RESTROOM MODIFICATIONS TO THE
ARLANZA COMMUNITY CENTER

7950 PHILBIN AVE. RIVERSIDE, CALIFORNIA

CITY OF RIVERSIDE
SET ___ OF ___ SUBMITTAL DATE: MAY 30, 1996
ADDRESS....: 7950 PHILBIN AV
LOCATION....:
APPLICANT...: CITY OF RIVERSIDE-WENDY BEEH
PHONE #....: 909 715-5470
DESCRIPTION: PARKING LOT HANDICAP STRIPING & MODIFICATION TO RESTROOM
APN: 145-010-031
FIRE #: 96-1-3523
PLAN CHECK NO: 2-E
SUBMITTAL: 1ST 2ND 3RD
APR 2

RESTROOM MODIFICATIONS TO
ARLANZA COMMUNITY CENTER
RIVERSIDE, CA.
7950 PHILBIN AVE

PARTIAL FLOOR PLAN
1/2"=1'-0"

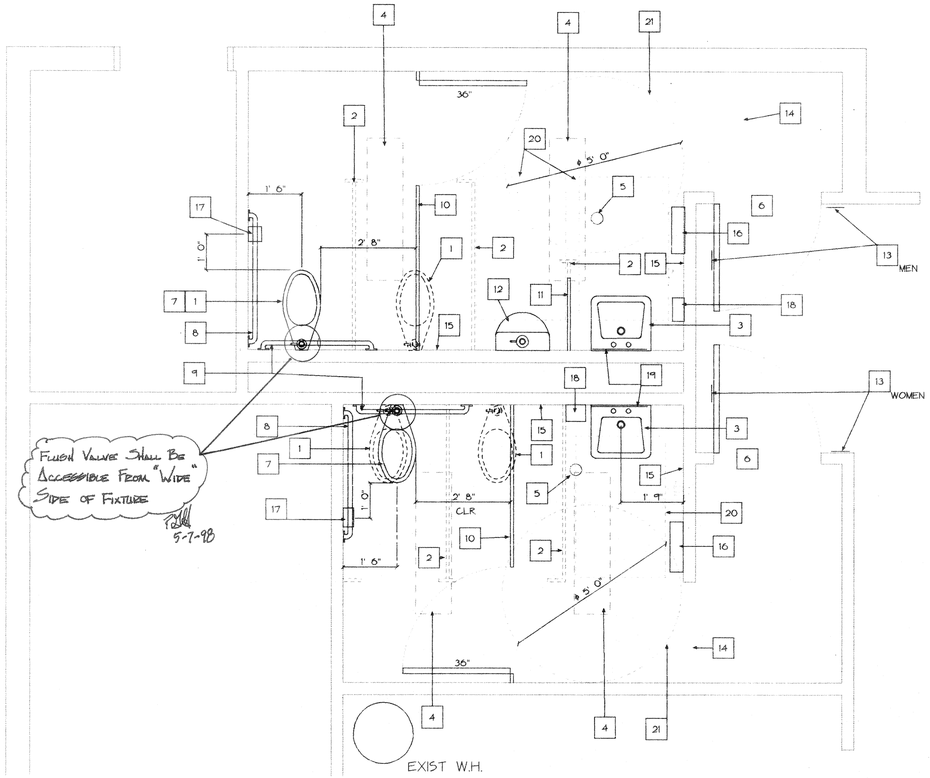
FLUSH VALVE SHALL BE ACCESSIBLE FROM "WIDE" SIDE OF FIXTURE
5-7-98
